**General Bid Bulletin No. 4**  
October 25, 2017

**Invitation for Bid No. 17-065-3**

***Expansion of the Existing Depot at Baclaran and  
Construction of a New Satellite Depot at Zapote for  
Light Rail Transit (LRT) Line 1-South (Cavite) Extension Project***

PACKAGE:	EXPANSION OF EXISTING DEPOT AT BACLARAN AND CONSTRUCTION OF NEW SATELLITE DEPOT AT ZAPDTE
DRAWING TITLE:	<b>BACLARAN DEPOT ADMINISTRATIVE BUILDING DEMARCATION LINE</b>
CAD FILE #:	
Dwg. #:	Rev. #: -

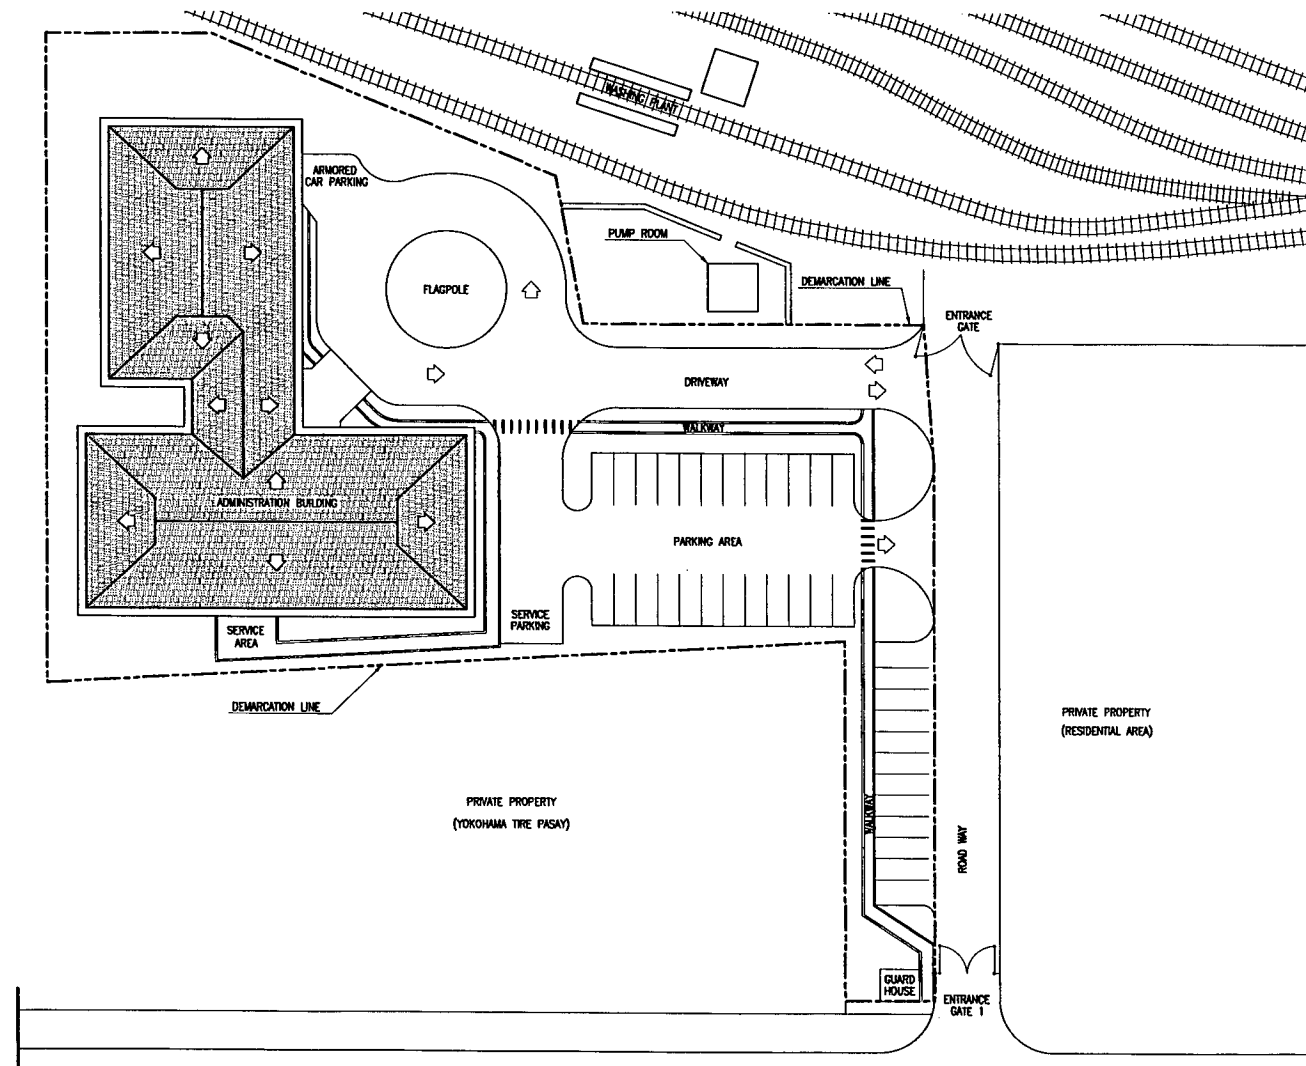
No.	Section No.	Page No.	Clause No./ Title	Clarification Request	Response								
<b>PART 2</b>													
1.	VI-2		Employers Requirements Technical Requirements/ General Specifications 9.13 Works Area	<p>We would like to request drawing(s) showing a clear extent/limit of Works Area at Baclaran Depot.</p> <p>Under the Contract, there is an existing building that requires to do improvement work, however, this is not included in the Works Area.</p> <p>Therefore, please specify the limits of the Contractor's Works Area for the Expansion Works at Baclaran Depot. Contractor's Works Area are not defined for the Admin Building renovation works.</p>	Please refer to the attached drawing "Baclaran Depot Administrative Building Demarcation Line"								
2.	VI-2		<p>Site Facilities for Employer and Engineer</p> <p>Technical Requirements General Specification</p>	<p>Table 16.1 Service Vehicle</p> <table border="1" data-bbox="893 934 1687 1044"> <thead> <tr> <th>Item</th> <th>User</th> <th>Type of Vehicle</th> <th>Quantity</th> </tr> </thead> <tbody> <tr> <td>1</td> <td>Employer</td> <td>SUV (eq. Innova)</td> <td>4 x 48MM</td> </tr> </tbody> </table> <p>Refer to above table, please clarify: 1) What is the meaning of 48MM?</p>	Item	User	Type of Vehicle	Quantity	1	Employer	SUV (eq. Innova)	4 x 48MM	1) 48MM means contract period (24months) plus Defects Notification Period (24months).
Item	User	Type of Vehicle	Quantity										
1	Employer	SUV (eq. Innova)	4 x 48MM
